SUBJECT: NOTIFIES OF PLANS TO REPLACE REACTOR PRESSURE VESSEL
 RECIRCULATION NOZZEL SAFE END & THERMAL SLEEVES. MOD AIMED AT
 INCREASING RELIABILITY & PROTECTION AGAINST INTERGANULAR
 STRESS CORROSION CRACKING.

SUSQUEHANNA STEAM ELECTRIC STATION
RECIRCULATION RISER PIPING MODIFICATIONS FOR IGSCC
ER 100450 FILE 883
PLA-350

FIGURE 1

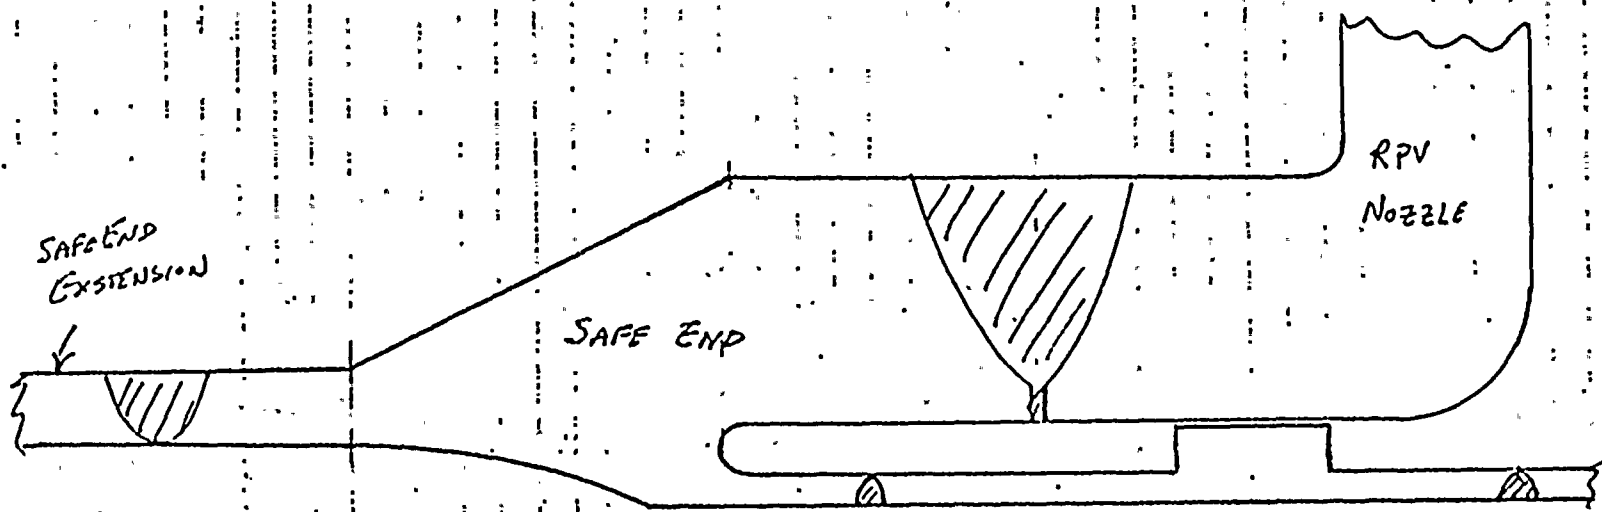
A modified design of the thermal sleeve on the reactor recirculation piping inlet to the vessel has been proposed by General Electric NEBG and PP&L has elected to incorporate this change into the Susquehanna design. This change in design is basically an effort to provide a geometry which is more optimized for resistance to IGSCC. The attached sketches provide outlines of the old and new designs (Figure 1). The changes will be accomplished in accordance with ASME Section XI, 1974 Edition with addenda to and including the summer 1975 paragraph IWA-4100. The additional ASME codes used for this modification are:

All welders and welding operators will be qualified in accordance with the requirements of the ASME code. Appropriate procedures will be written for this installation. Unit #1 and #2 material for the replacement of safe ends and thermal sleeves will be Type 316L.
